**Change of Access on Recorded Plat
TMAPC July 21, 2010**

Lot 4, Block1, Harvard Square South – (9328) (PD 6) (CD 9)
East of the Southeast corner of East 41st Street South and South Harvard Avenue

CHANGE OF ACCESS
FOR
LOT 4 IN BLOCK 1
OF

'HARVARD SQUARE SOUTH'
SECTION 28, T-19-N, R-13-E
CITY OF TULSA, TULSA COUNTY, OKLAHOMA

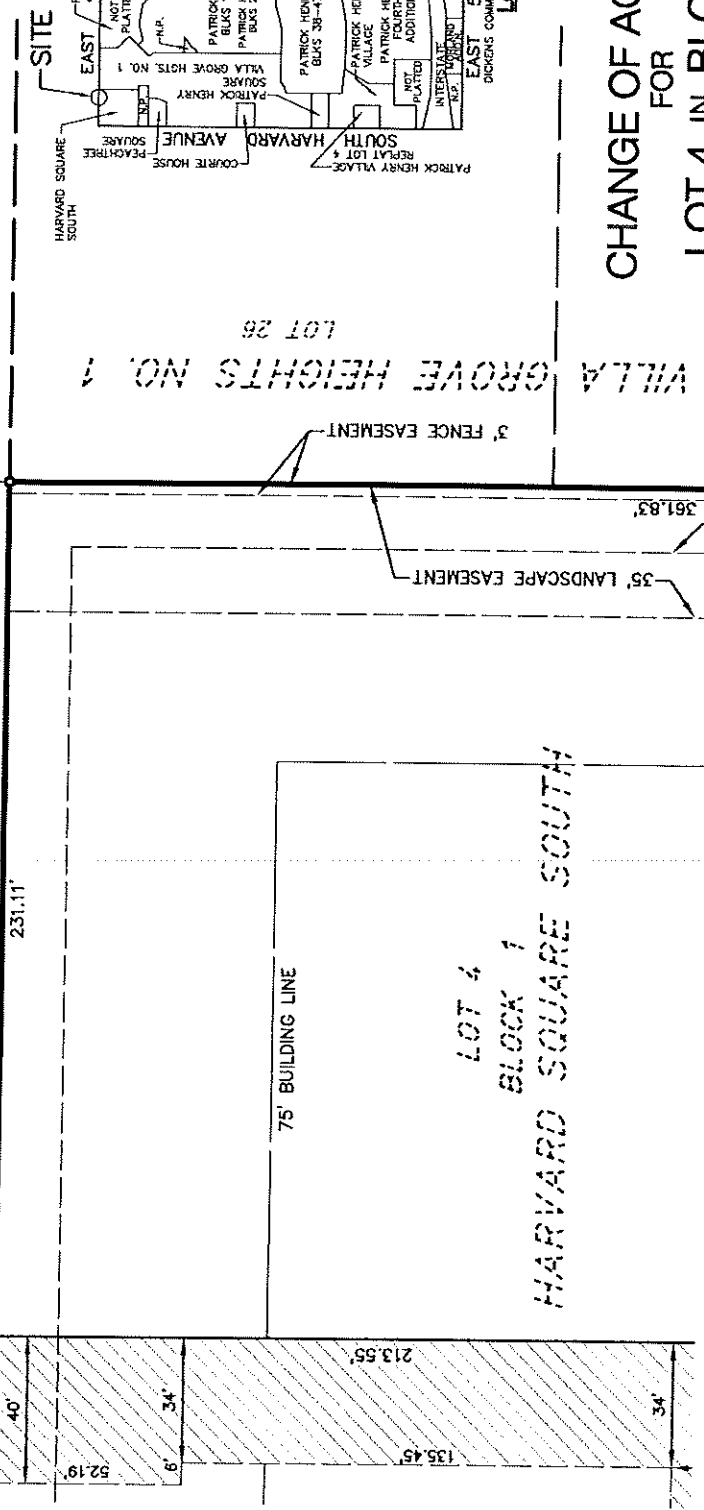
This application is made to allow a change of access to shift an existing access to the west along East 41st Street South. The property is zoned PUD 761.

Staff recommends approval of the change of access. The Traffic Engineer has reviewed and approved the request. Staff recommends **APPROVAL** of the change of access as submitted.
